MCW Consultants Ltd.

Addendum

Project Name: AQUAVISTA - Bayside
Client: TRIDEL Corporation
To: TRIDEL Corporation
Attention: Chadi Loza
Fax number: -

Title: Various Electrical Changes.

As Indicated
Author
Checked By
84890
08/28/12
Drawing No.
E4-05

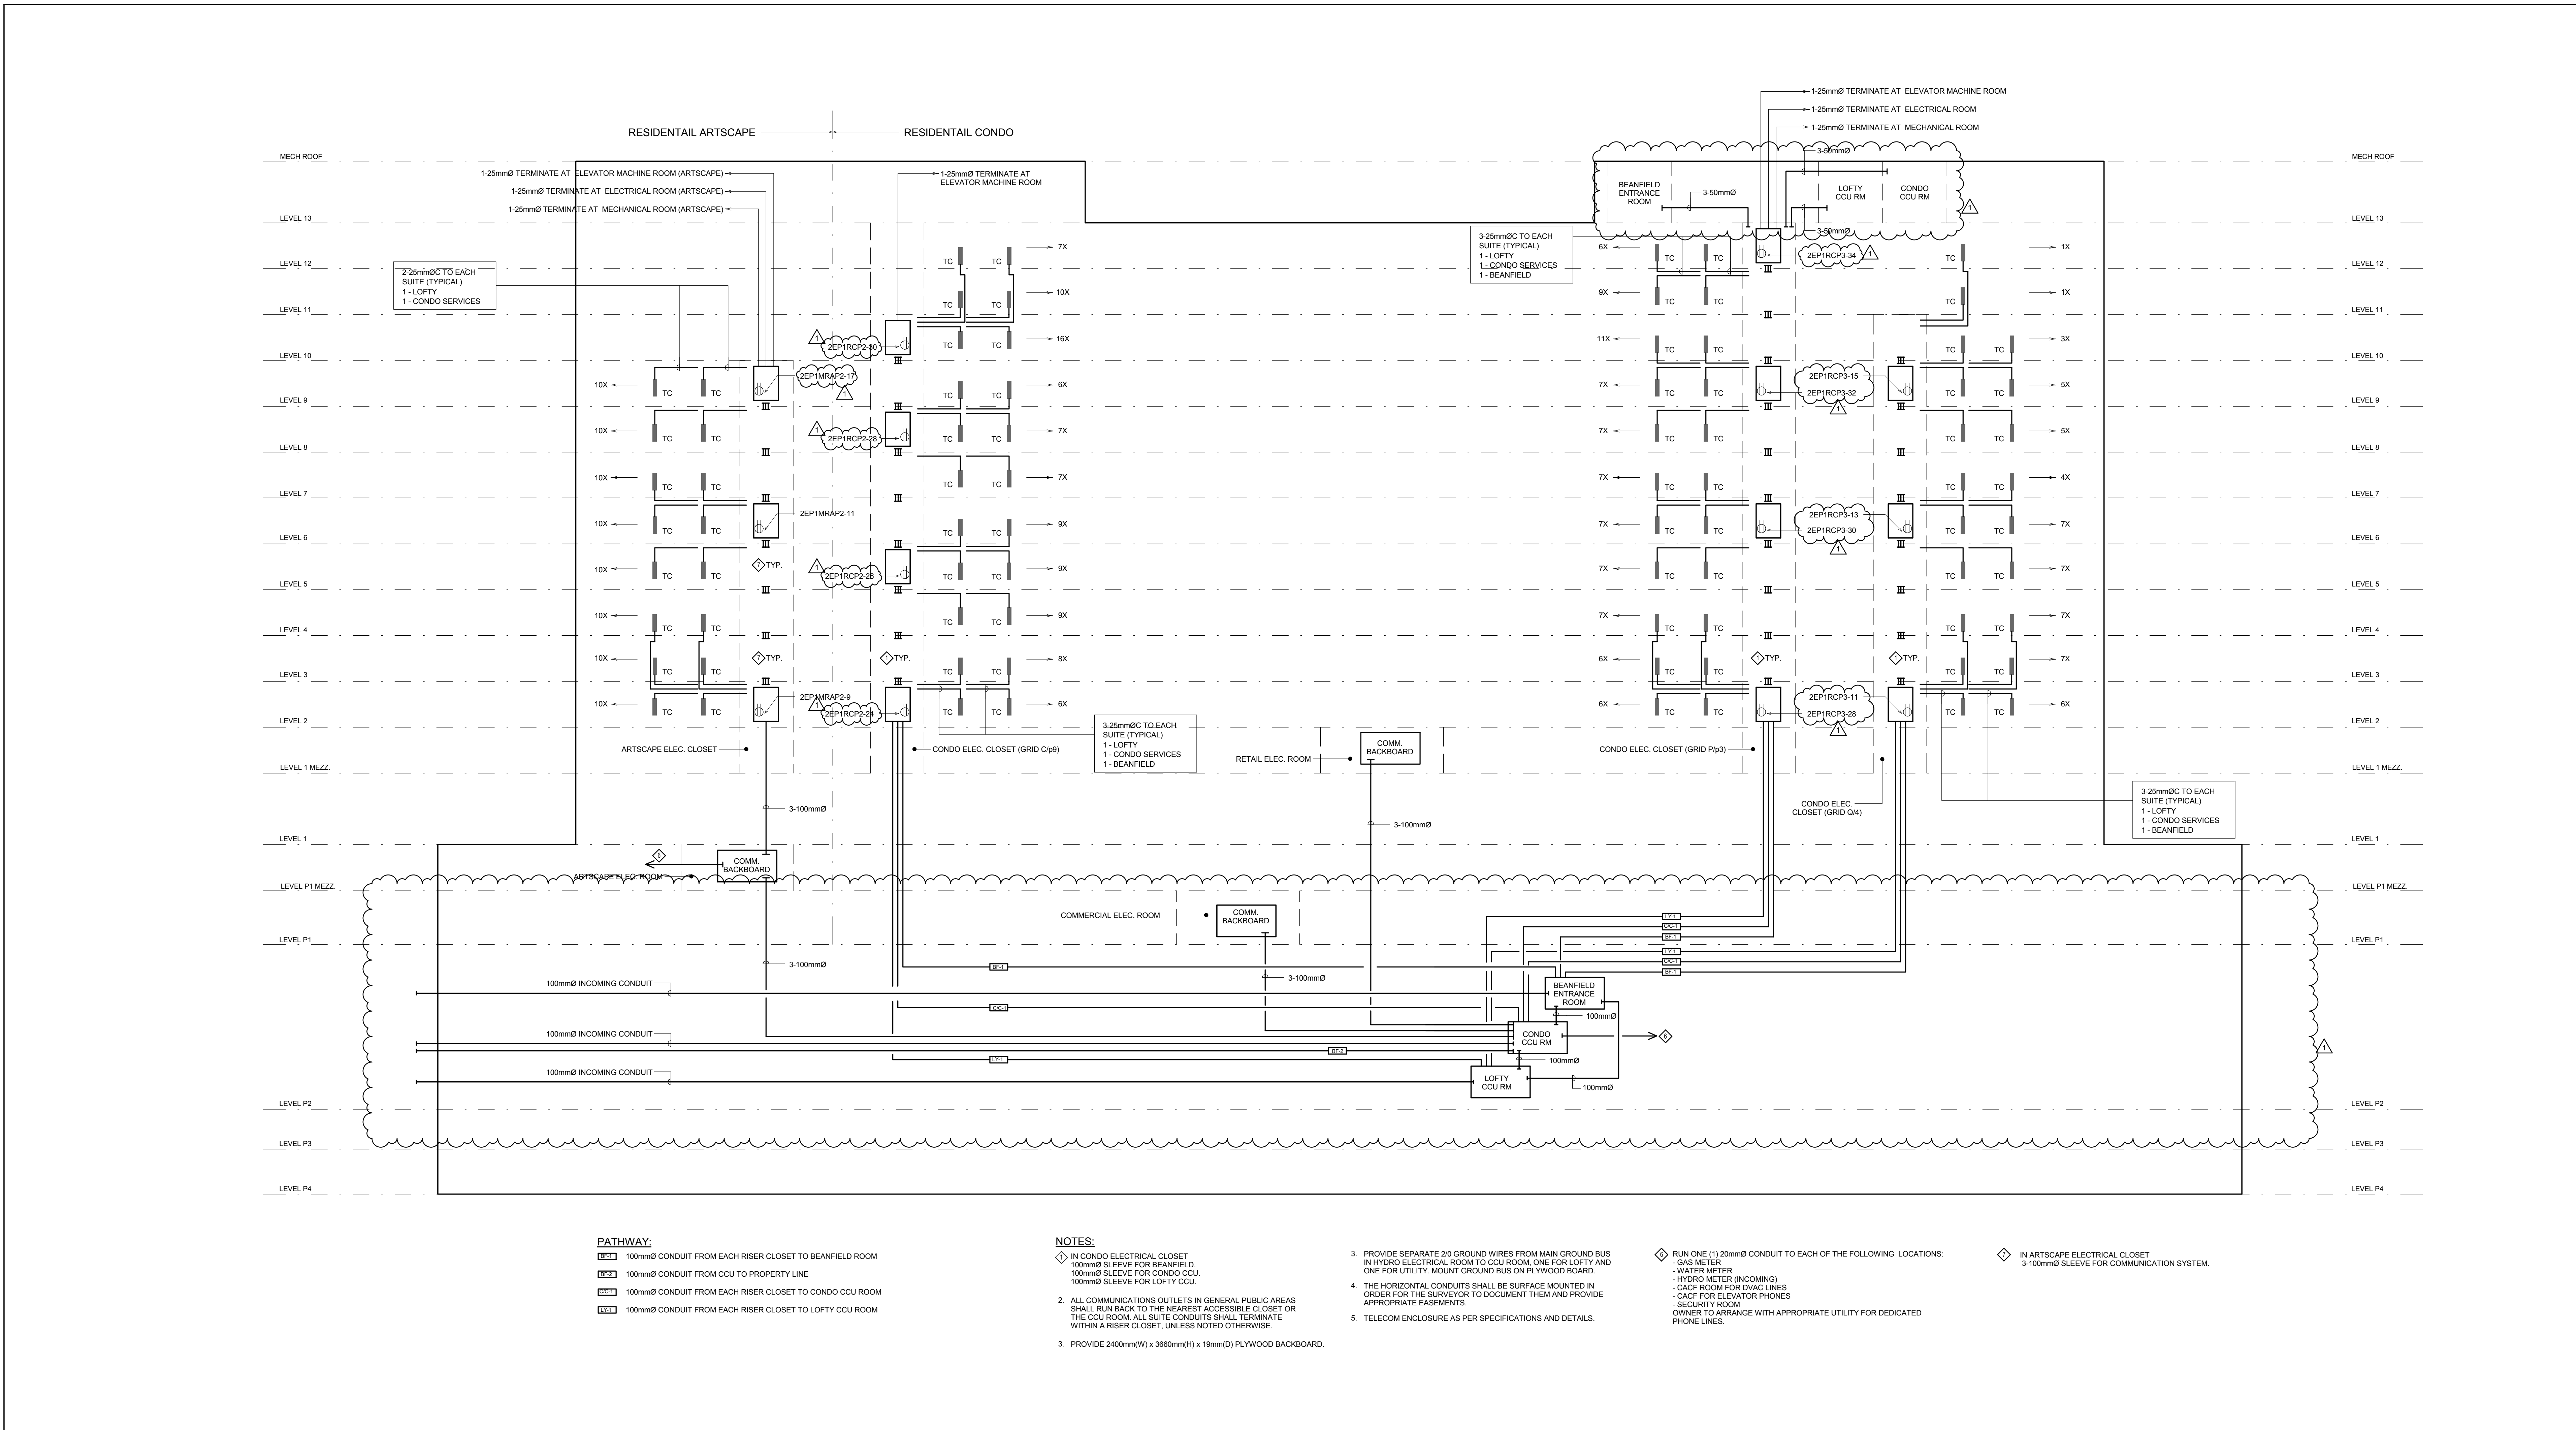
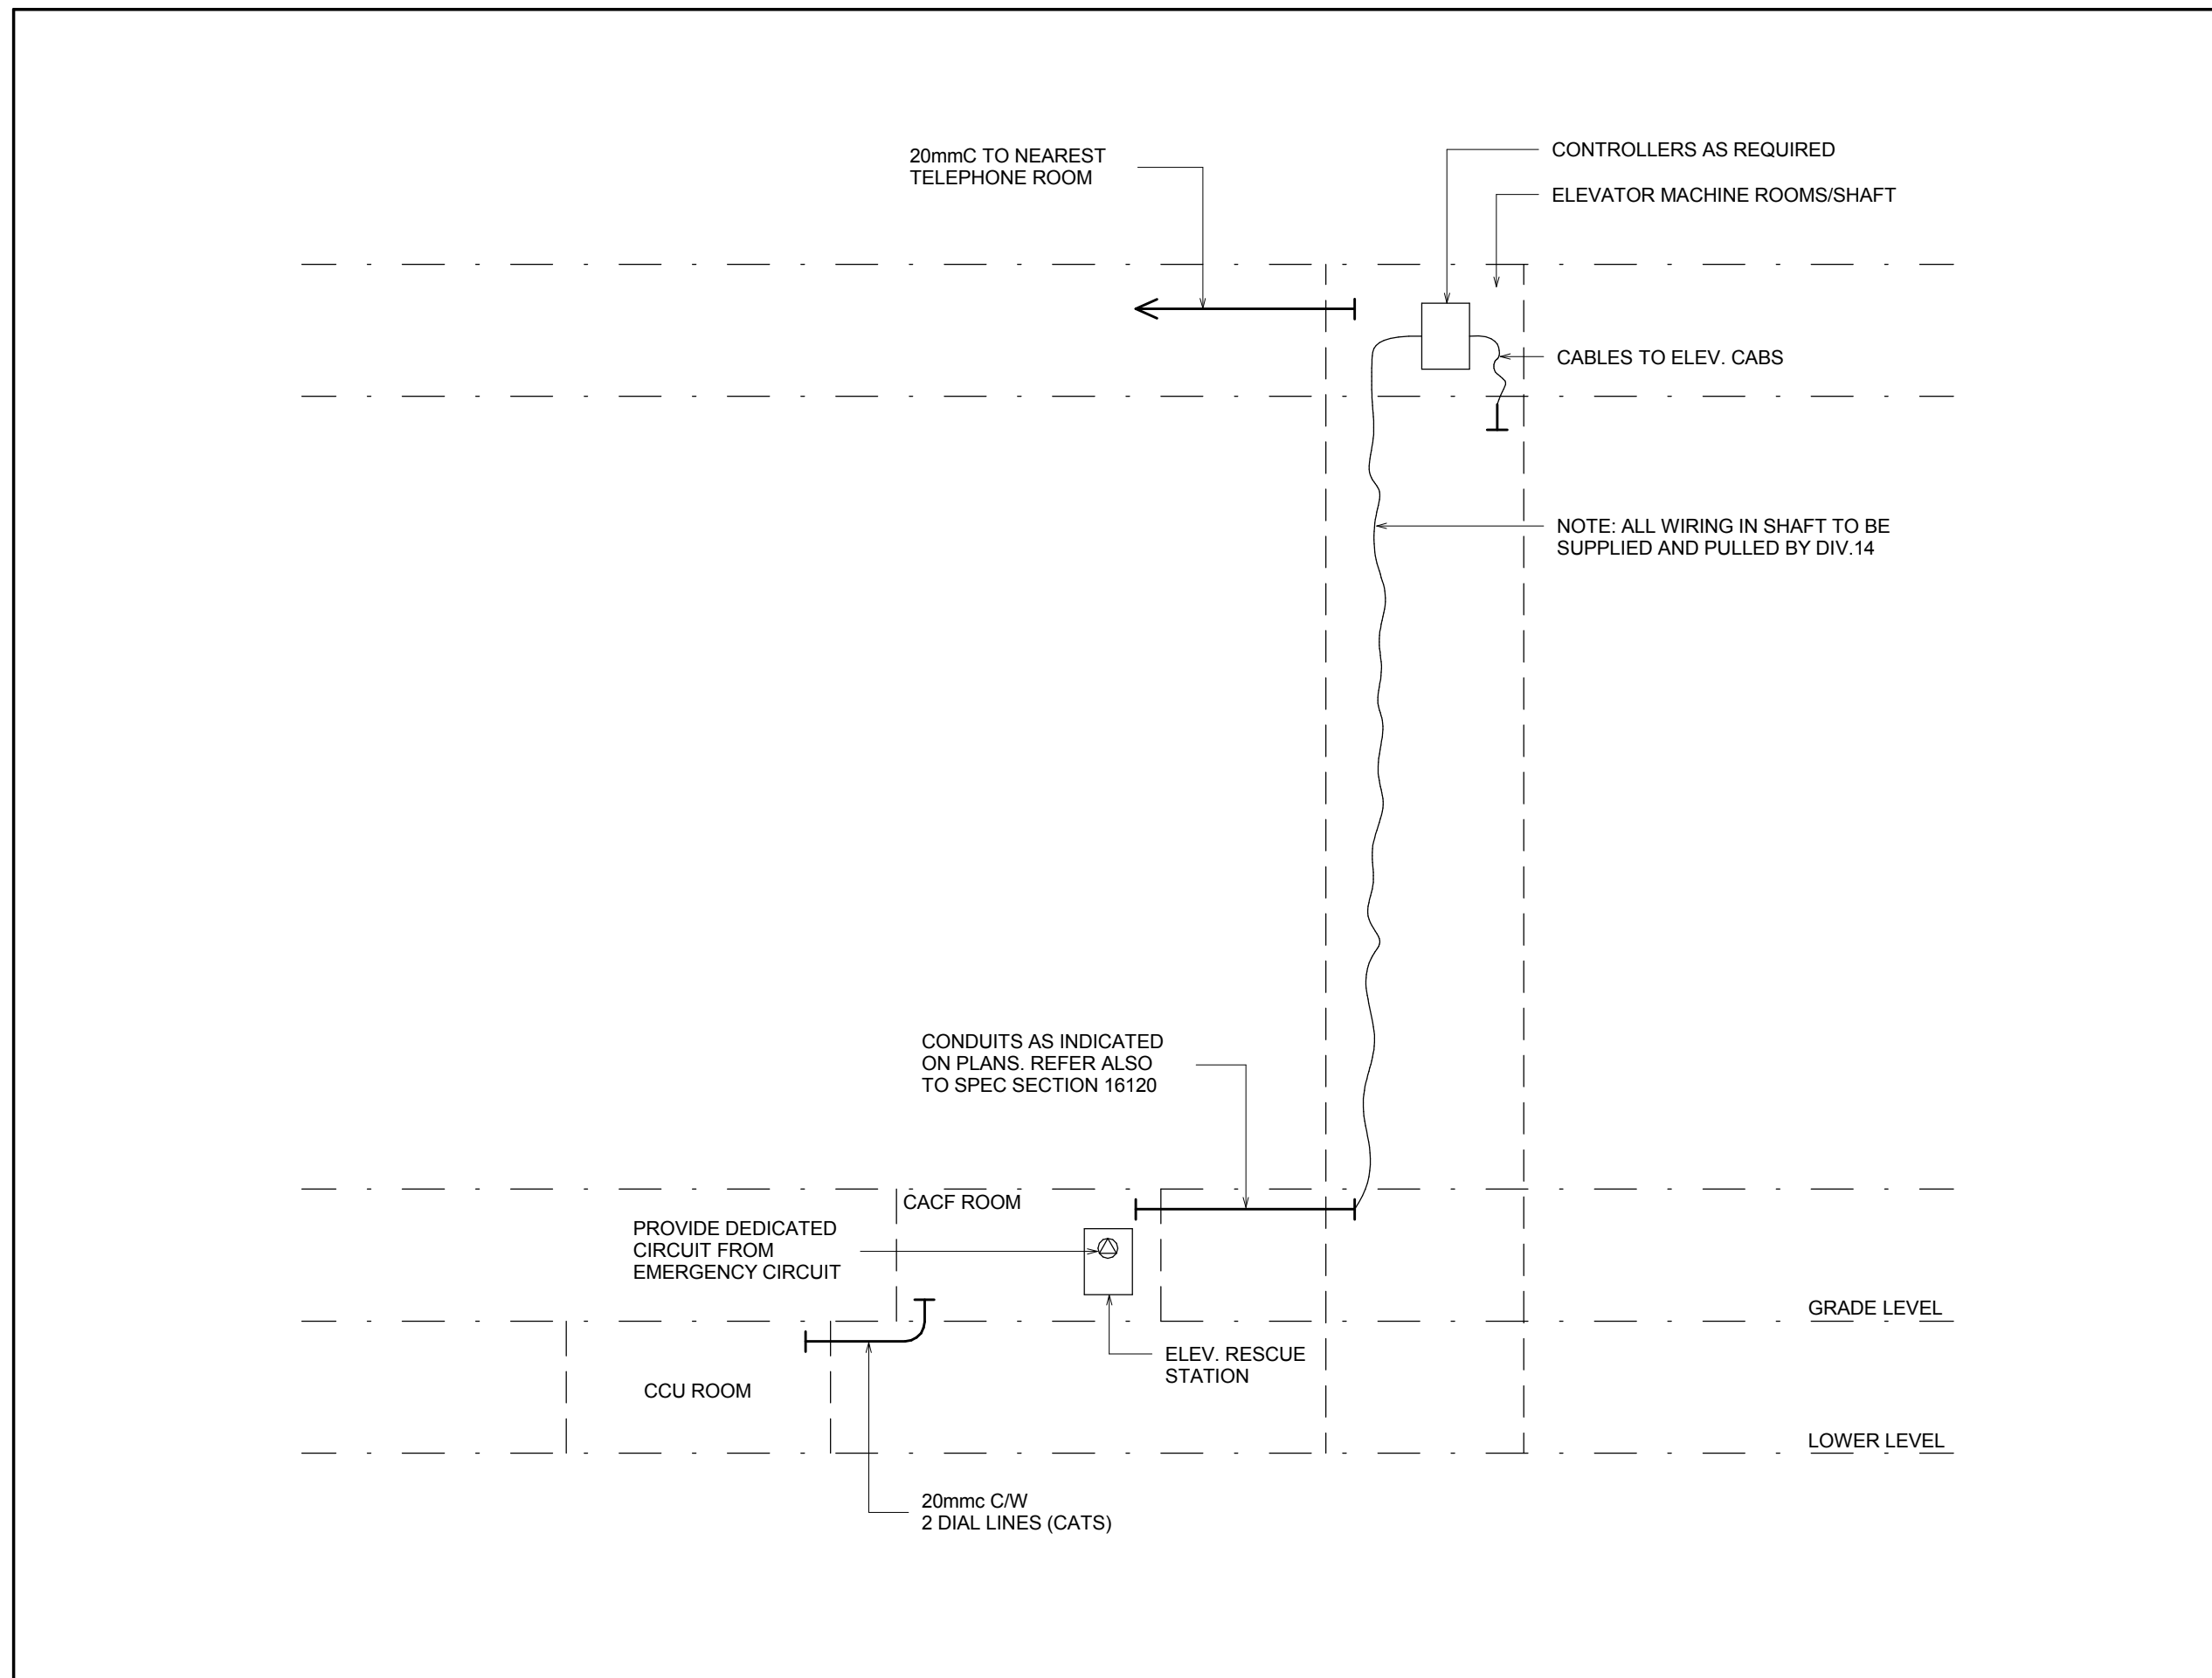
E3-01-RC	Yes	Distribution riser has been updated showing the correct location of panel 'P-2EP1RCP3'.
E4-03	Yes	Add remote fire alarm annunciator on retail fire alarm raiser as shown.
E4-04	Yes	Add fire alarm zones as shown.
E4-05	Yes	- Revise communication panel circuit number as shown. - Revise communication riser as shown.
E5-01	Yes	- Park electrical room layout has been updated. - Add emergency lighting battery unit in park electrical room as shown. - Add fire alarm smoke detectors and speaks to east electrical room and commercial room as shown. - Relocate panel 'P-2EP1RCP3' from main electrical room to east electrical room as shown. - Relocate panel 'P-2COMM' from main electrical room to lofty CCU room as shown. - Add new detail drawing for CCU rooms and Beanfiled entrance room as shown.
